ADDENDUM NO. 1
TO
CONTRACT DOCUMENTS
FOR
THE CITY OF IRONWOOD
COUNTRY CLUB ROAD 2019 WATERMAIN REPLACEMENT PROJECT
IRONWOOD, MICHIGAN
April 12, 2019

This Addendum No. 1 consists of one (1) page with twenty four (24) pages of attachments.

CONTRACT DOCUMENT MODIFICATIONS

HMA APPROACH SECTION 1

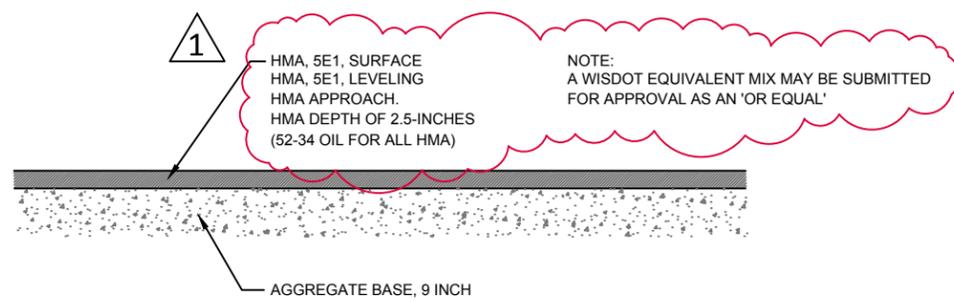
- The Bid Form has been modified to include the revised pay item quantities for Rock Excavation and adding the pay item and quantity in for Geotextile, Stabilization. A revised **Bid Form** (6 pages) has been attached to this Addendum.
- The asphalt section on sheet 2 has been modified as follows:
 - Both lifts of asphalt are to be 5E1 (or approved WisDOT equal)
 - A 52-34 oil shall be used for all HMA.
 - A “geotextile, stabilization” shall be used under the sand for the Elk and Hound water service trench.
